CITY OF ST. PETERSBURG, FLORIDA

STAFF REPORT

Community Planning and Preservation Commission Certificate of Appropriateness Request

Review of a Certificate of Appropriateness for the alteration of a front porch and new front door at 2754 4th Ave N, a contributing property to a local historic district.

Figure 2: Proposed doors, as shown in application

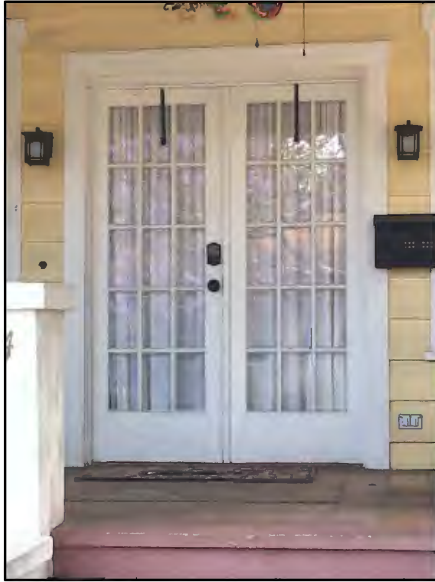
The proposed replacement door (Figure 2) is a fiberglass single-action door with sidelights. The door itself features a faux-lead glass panel at its upper portion and sidelights with a vertical-panel construction below. The sidelights also feature the faux leaded glass, which the applicant has stated the decorative glass is to create privacy. The overall design and configuration are generally consistent with recommendations provided by St. Petersburg's Design Guidelines for Historic Properties (Figure 3), although leaded glass is not a typical historic design element found locally on Craftsman-style homes. Nonetheless, the design generally references the Craftsman design aesthetic.

Since the original entryway's configuration and design is unknown, the proposed partially-glazed door with sidelights are appropriate and recommended as a feature of the Craftsman style by St. Petersburg's *Design Guidelines for Historic Properties*, although the use of beveled glass is not traditional to the Kenwood neighborhood. The applicant has stated the need for beveled glass to create privacy. A solution could be to use a frosted glass film or traditional curtains or shades to provide privacy.

Inconsistent The exact configuration and stylistic details of the original entryway at the subject property are unknown. While the proposed design of the door is appropriate to the district, staff finds the introduction of beveled glass, which is not traditional to the historic district, inappropriate and creating a false sense of development.

For the replacement front door, the opening and trim will be preserved and repaired as necessary. It is unknown what the original design of the front door was, but the proposed configuration of the door is compatible with the Design Guidelines with the exception of the faux-leaded glass in the door glazing and sidelights, which is not a traditional feature in St. Petersburg.

2. The glass in the proposed front doors should be clear or frosted with a film, without the use of faux-leaded glass.
3. Sidelights will be recessed in wall plane approximately 2 to 3 inches to provide consistency with existing historic windows.

Figure 4: Proposed PVC railing with tree cutout. Image from The Porch Company.

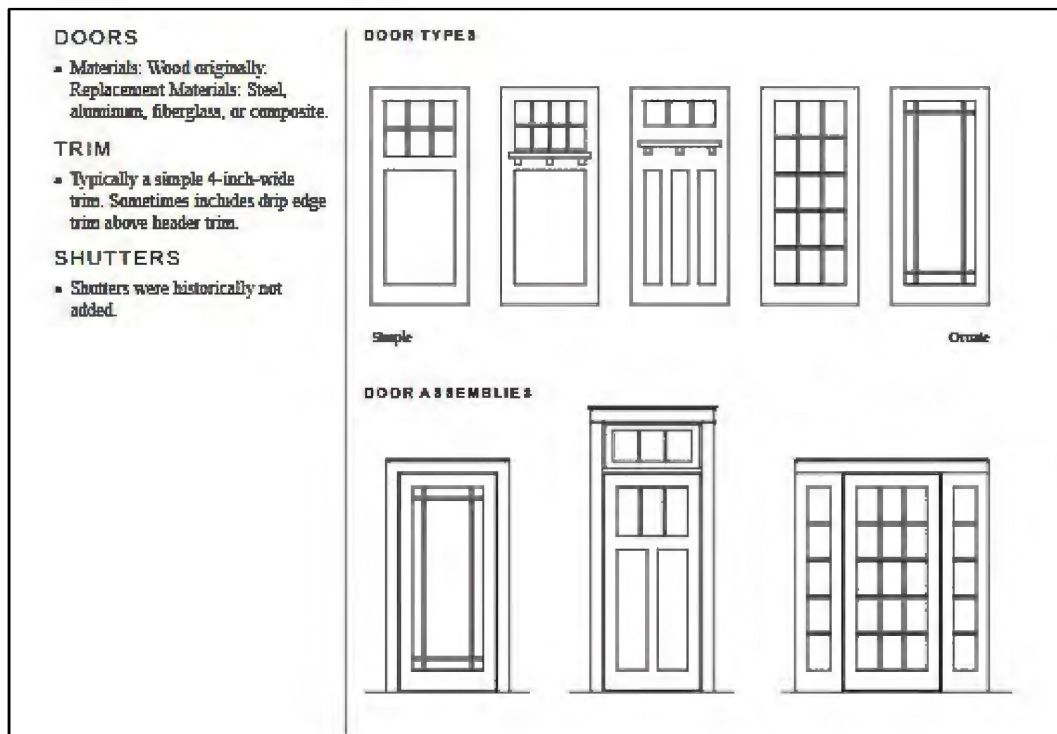
The proposed PVC railing with a decorative tree design does not match traditional railing styles in the historic district. There is no documentation of the proposed knee brace extensions, and the installation of these features might lessen the integrity of the subject property and create a false sense of history.

The proposed decorative PVC railing introduces a material and design that does not match traditional features of the historic district. While the railing is something that can be easily reversible, it would set a precedence for the introduction of non-traditional features in the local historic district.

The proposed PVC railing with a decorative tree and the proposed architectural features for the gable roof are not substantiated by any photographic or documentary evidence.

1. A replacement railing for the front porch should consist of wood and be architecturally compatible with the Craftsman style, per the *Design Guidelines for Historic Properties in St. Petersburg*.
